KERR-McGEE CORPORATION

APPLICANTS ENVIRONMENTAL REPORT

URANIUM HEXAFLUORIDE PLANT

SUPPLEMENTAL #2

SITE PLAN

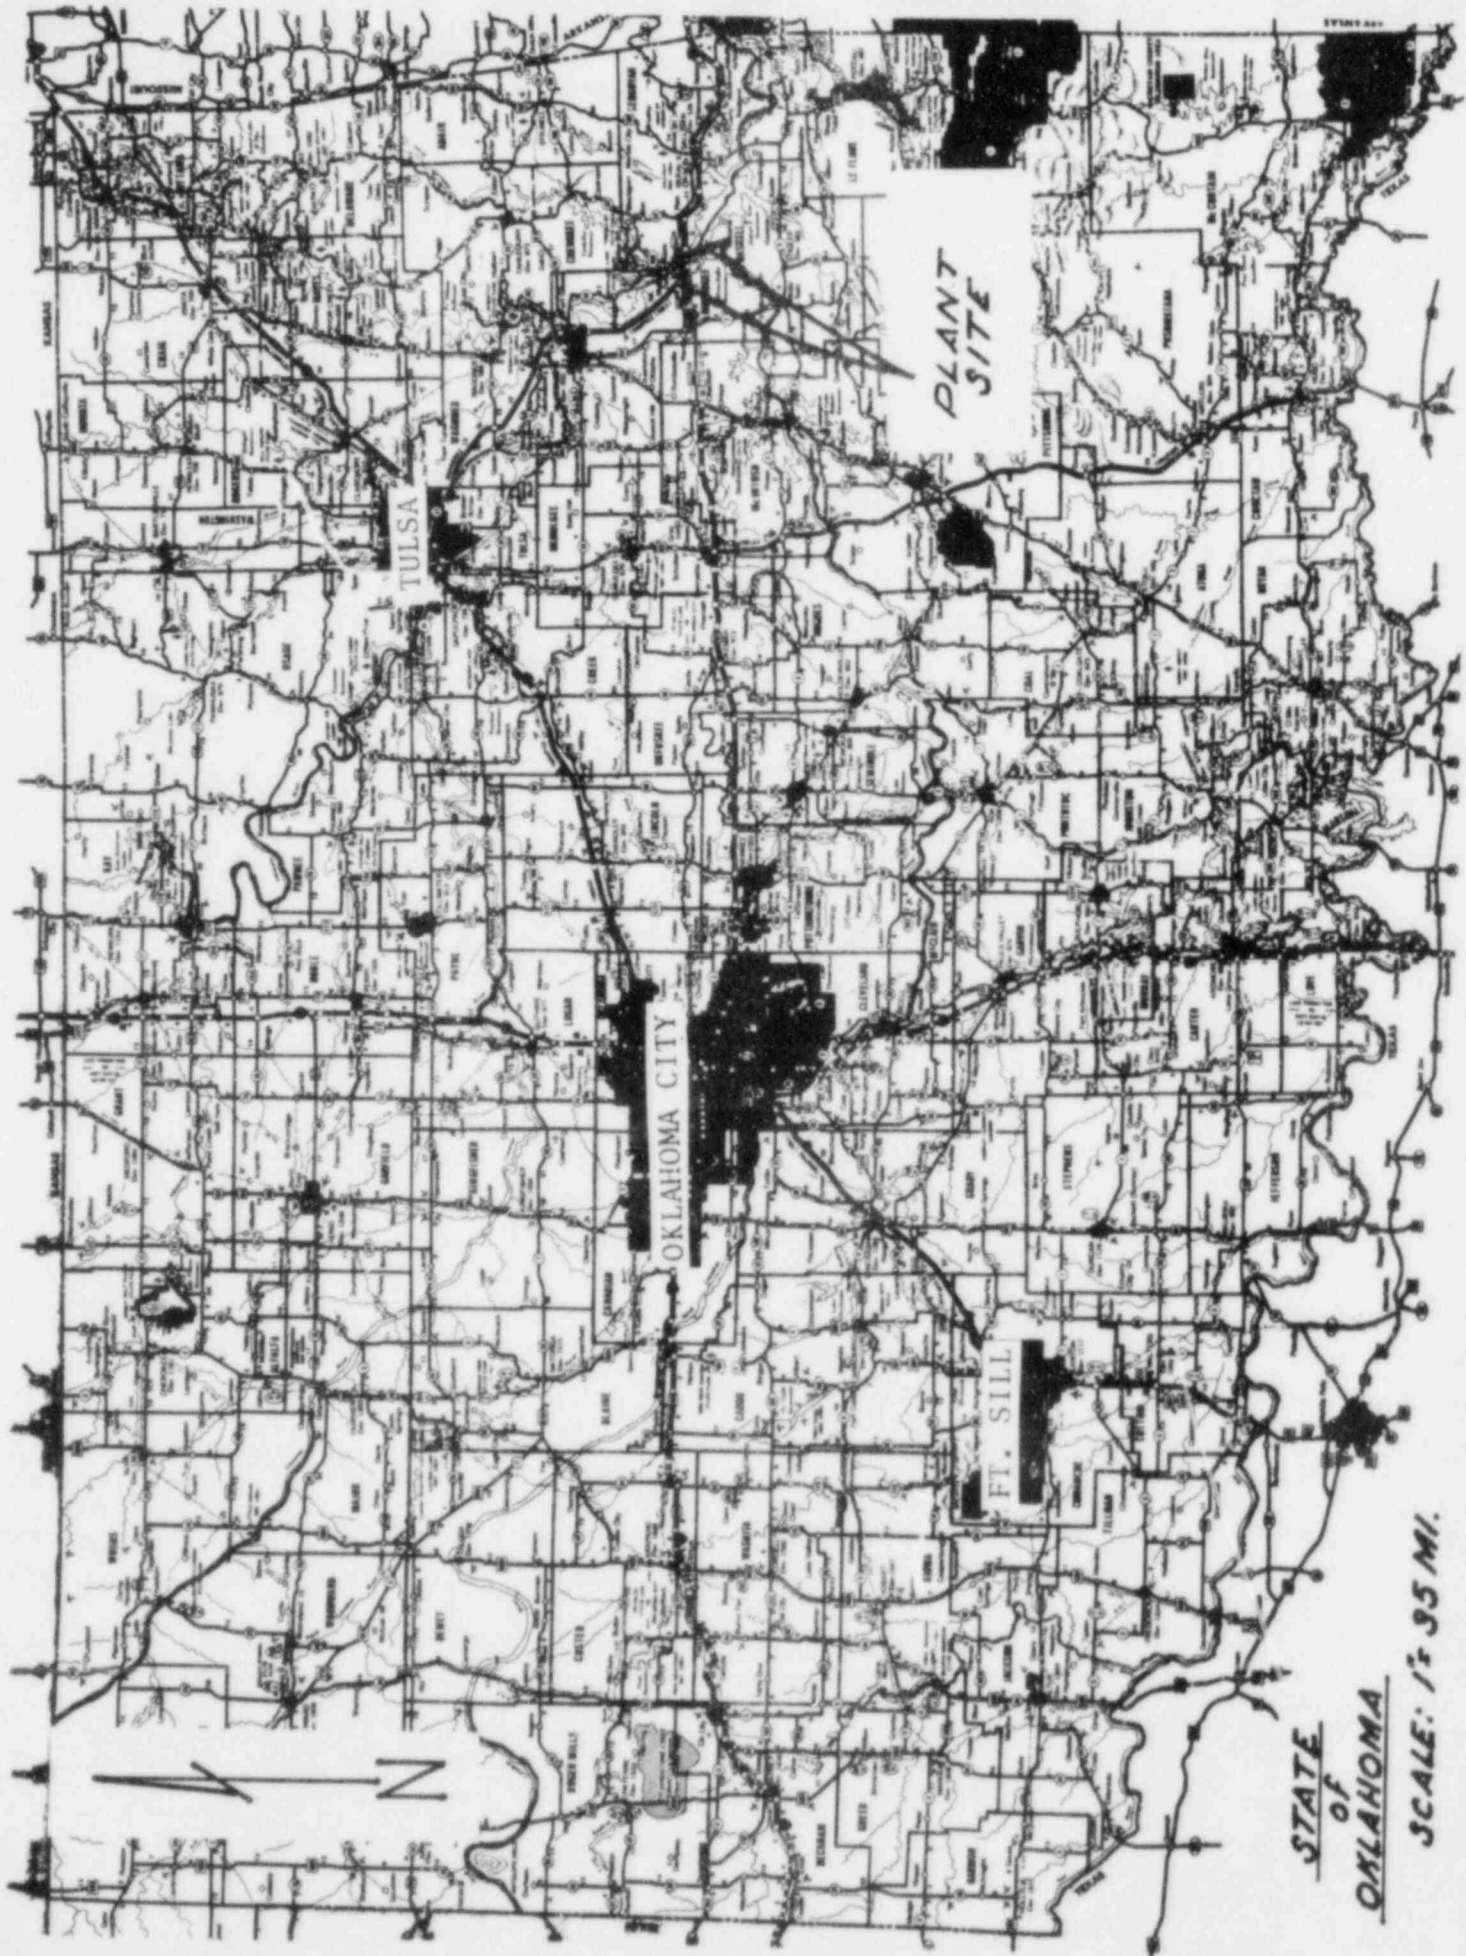
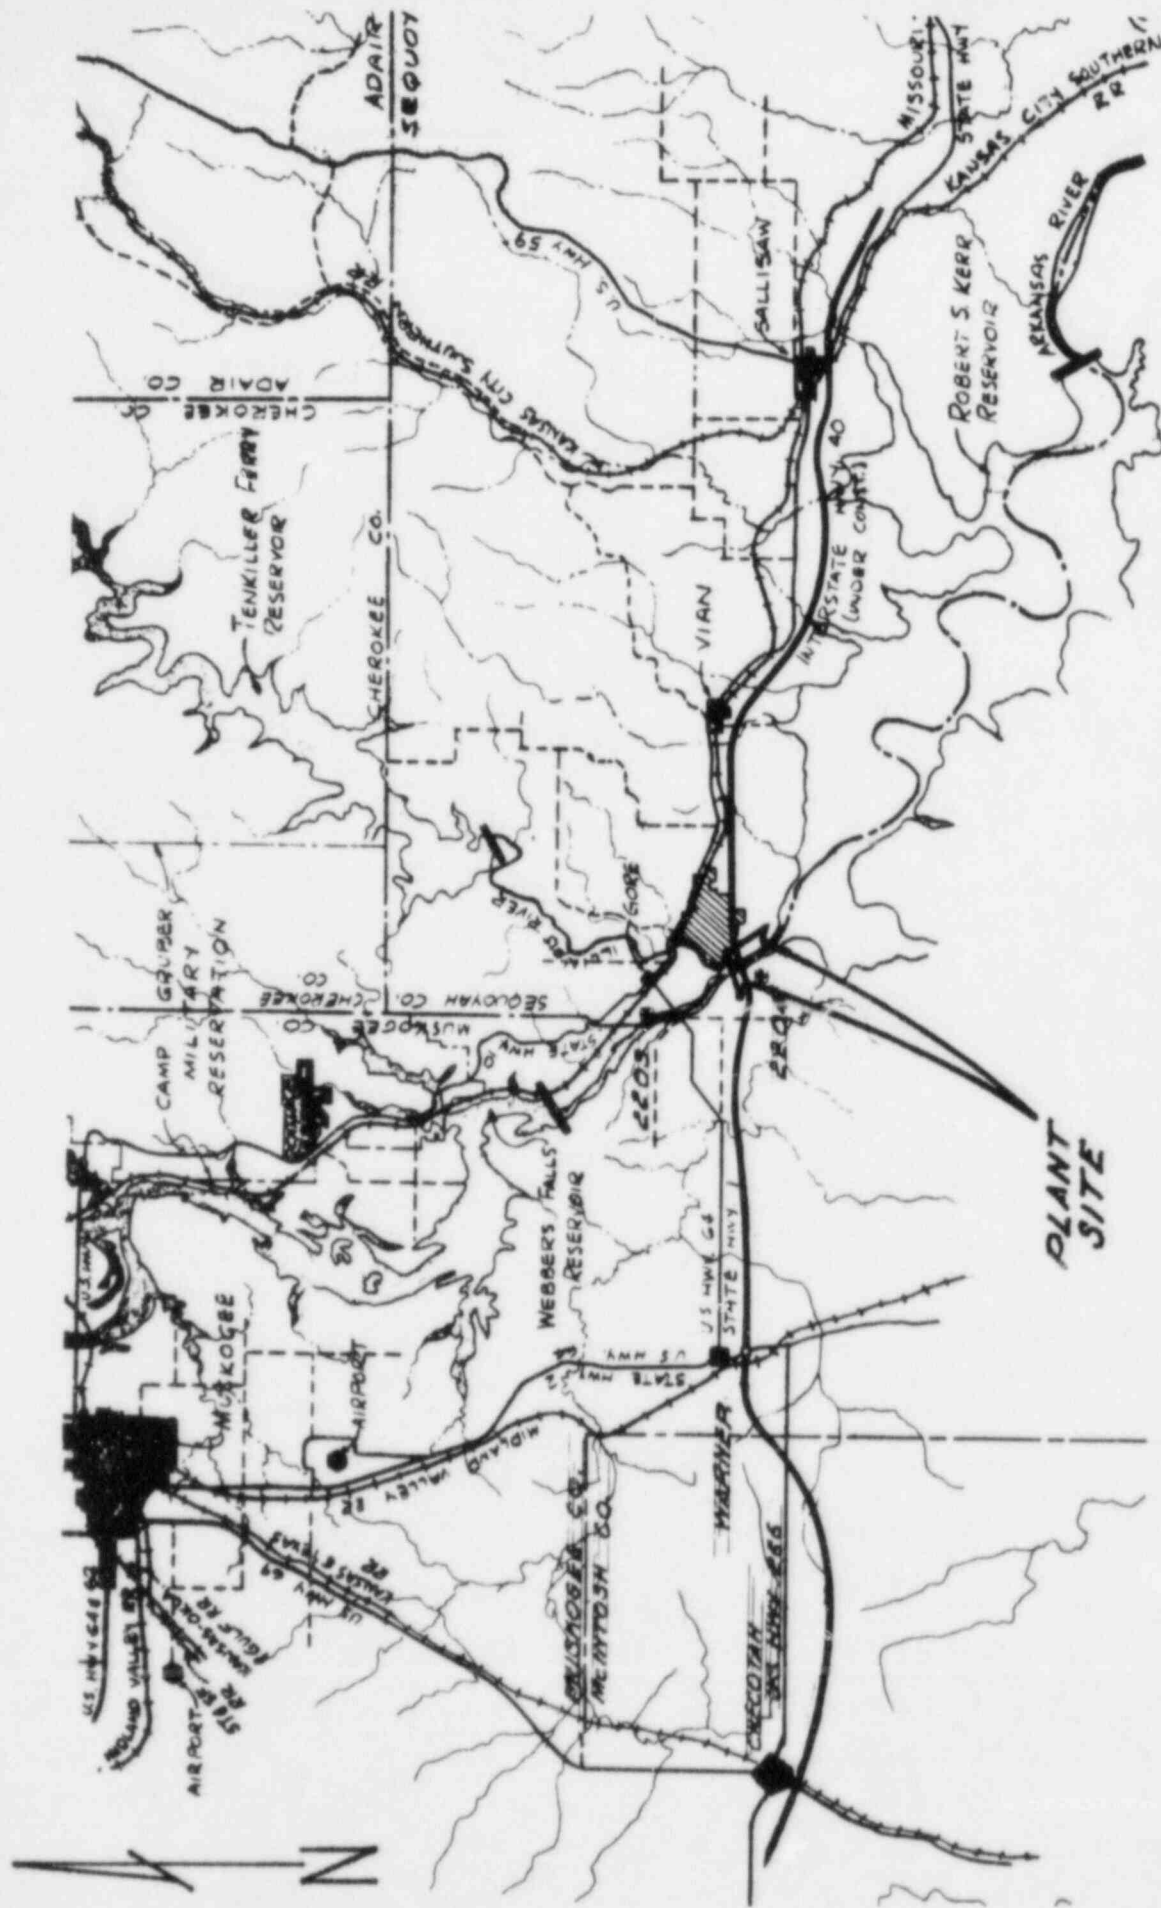
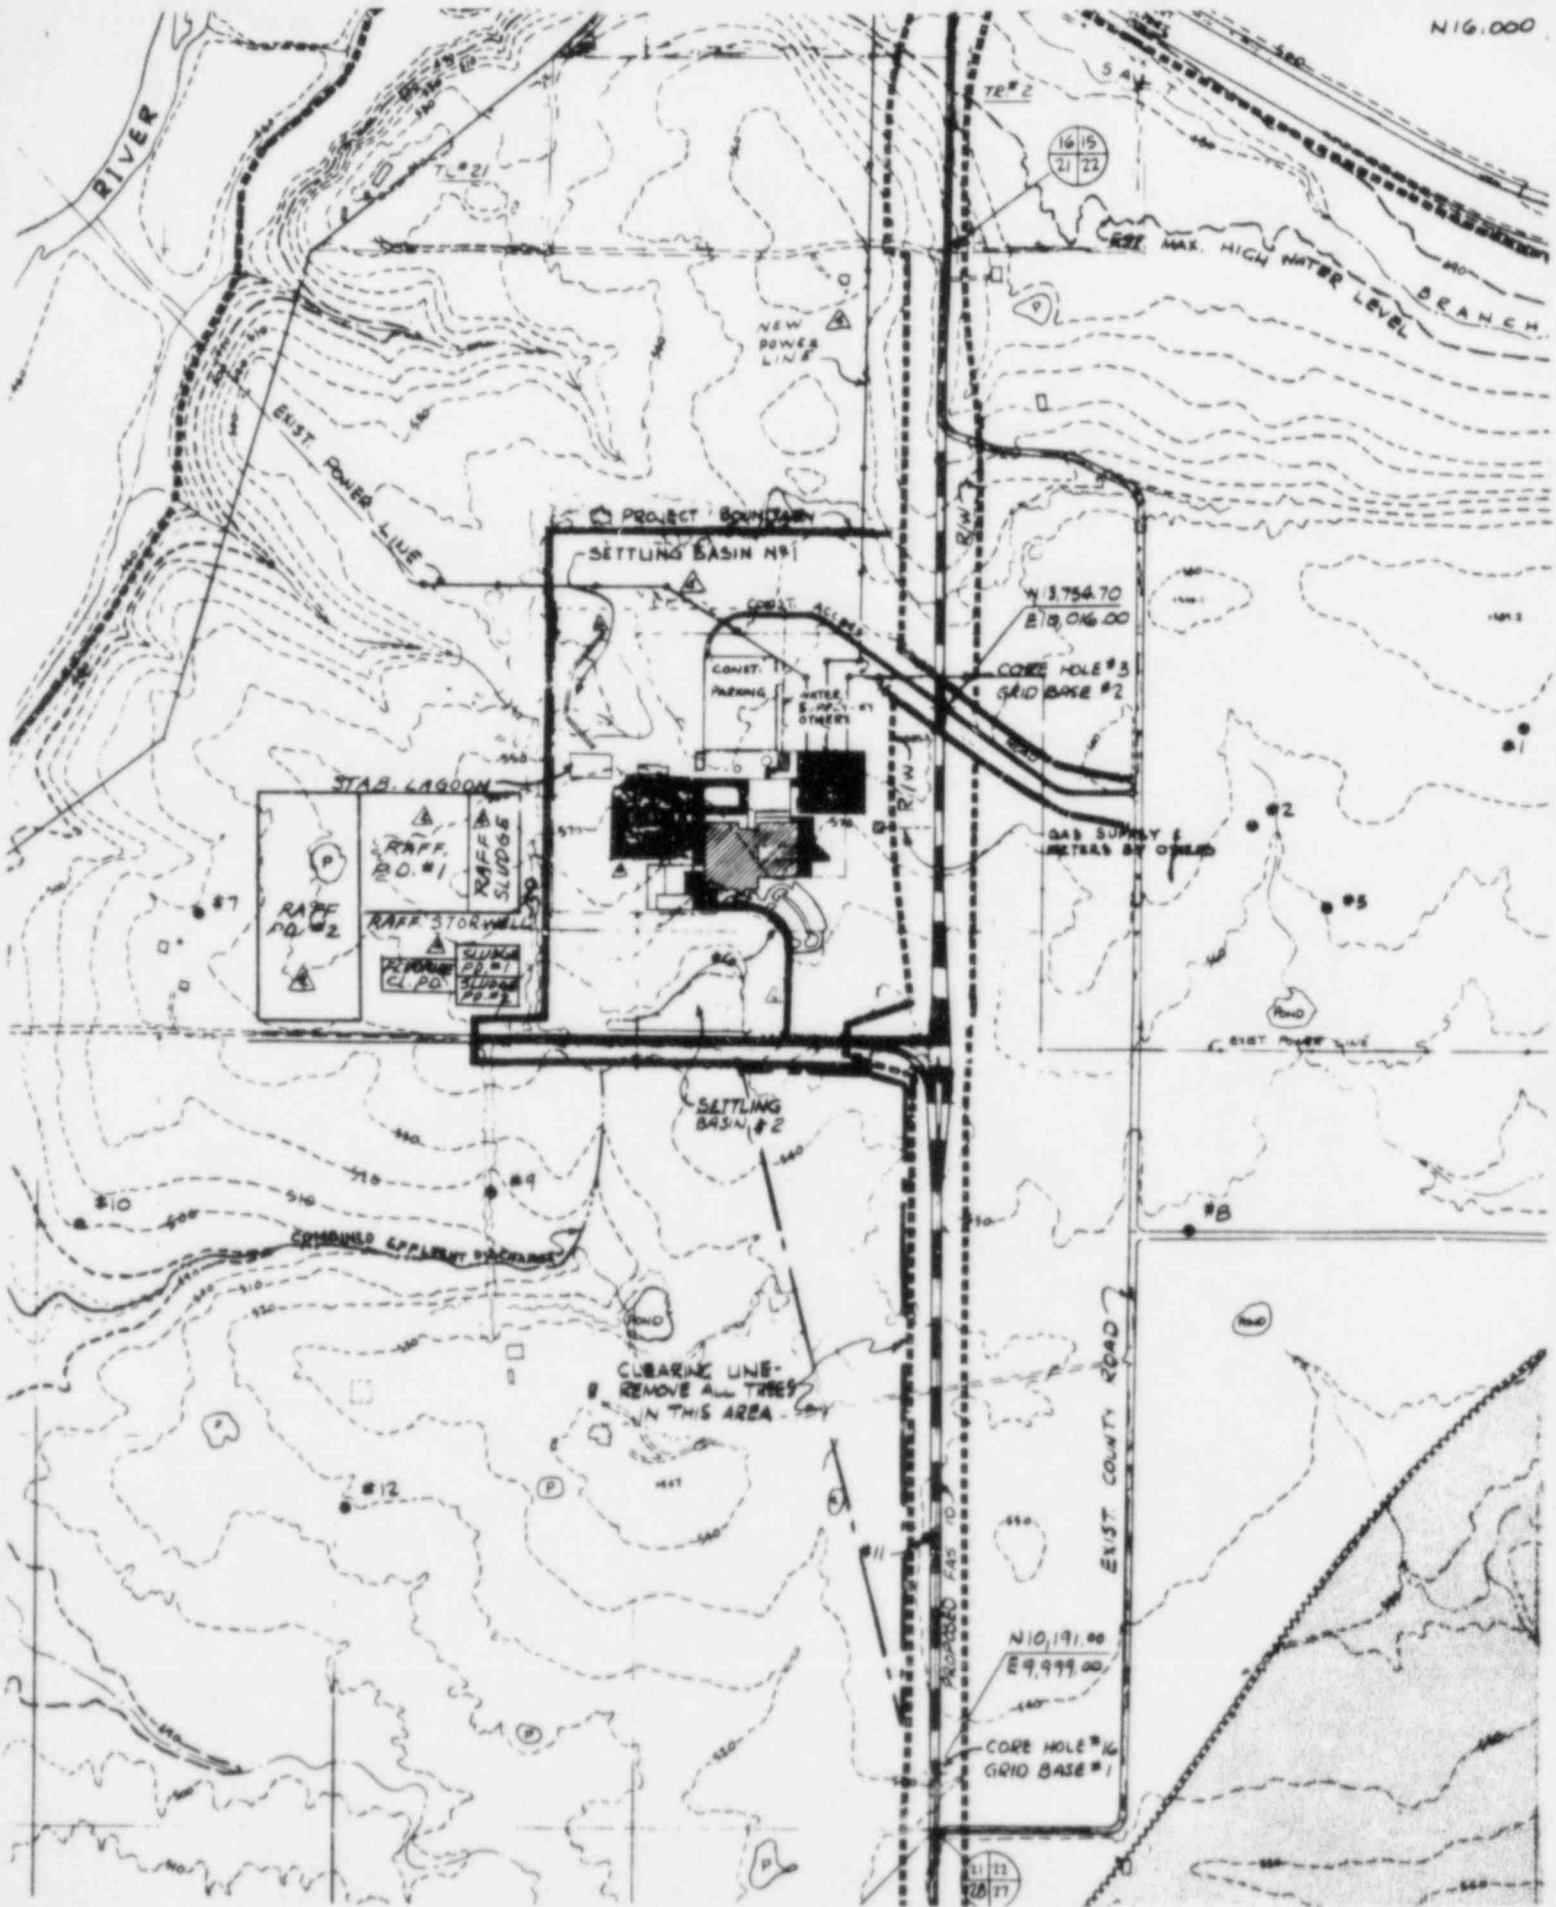
- (2) Maps provided (Figure 1 in particular) are not very clear. Suggest substituting following 8 x 10 1/2" drawings:
- (a) General map of State of Oklahoma pointing out plant site (scale about 50 miles per inch),
  - (b) Second map showing general area details i.e., towns, roads, rivers, etc. (scale about 10 miles per inch)
  - (c) Third map similar to insert in present Figure 1. (scale about 4 miles per inch)
  - (d) Plant area map (scale about 1500 feet per inch) up-dated to show all existing ponds, monitoring points, residences, etc. alone with distances from air-borne effluent release point to possible critical exposure points; e.g., school, homes, roads.

The maps requested are enclosed. We feel, however, that this request, if such fixed criteria for such reports exists, should be included in the guidelines for such reports. Figure 1 is a reduction of Drawing 110-C-151 included with the Revised Environmental Report. The location of the houses and school are circled and the distances tabulated.

SEQUOYAH FACILITY  
X - SECTION  
THROUGH HOLDING PONDS  
NOTE: VERT.-EXAG. 5:1  
12/72

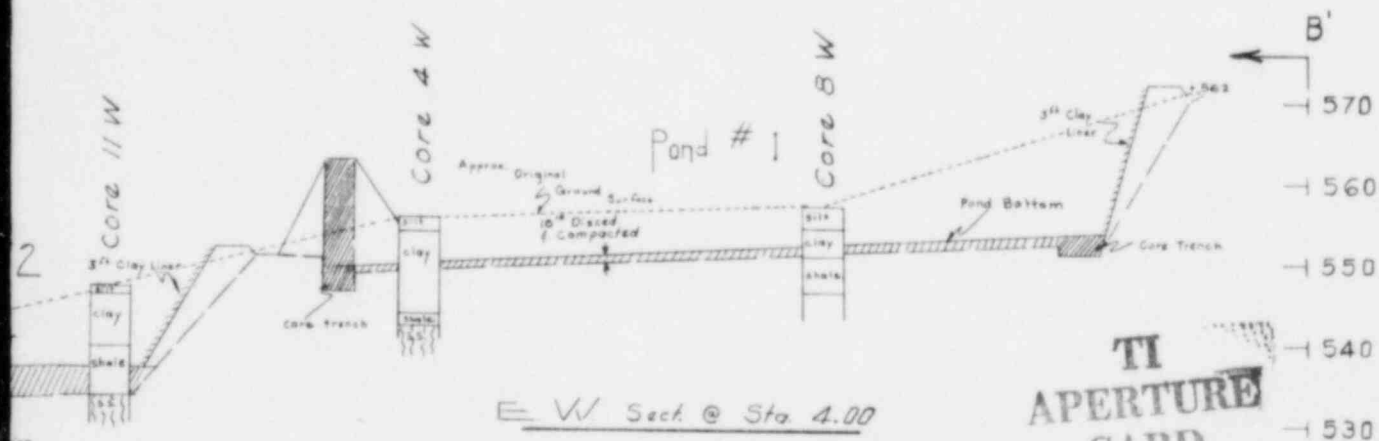
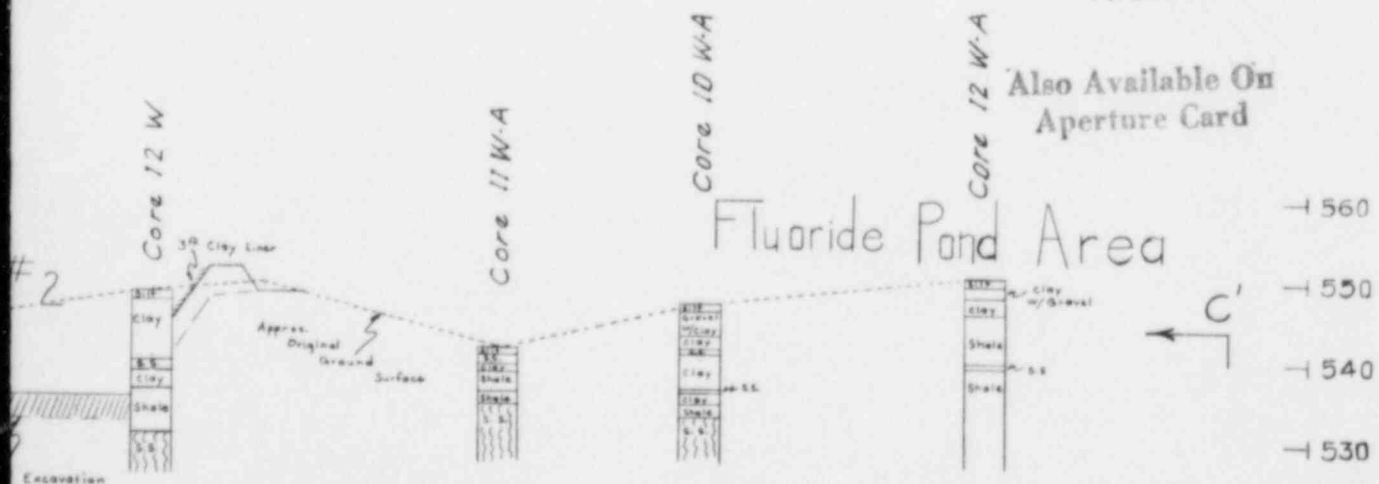
Questions relating to the raffinate pond construction (University of Colorado report) and levels of various analyses in monitoring wells (questions 11, 23, 36, D. L. Warner comments and University of Colorado comments) demonstrate concern that the raffinate storage ponds have leaked chemicals into the nearby monitoring wells.

As described briefly under question 38, clay linings and dike facings were subjected to permeability tests by standard methods

employed by soil engineers, demonstrating essentially no permeability to raffinate fluids exists as shown on the attached report by Hemphill Drilling Co.
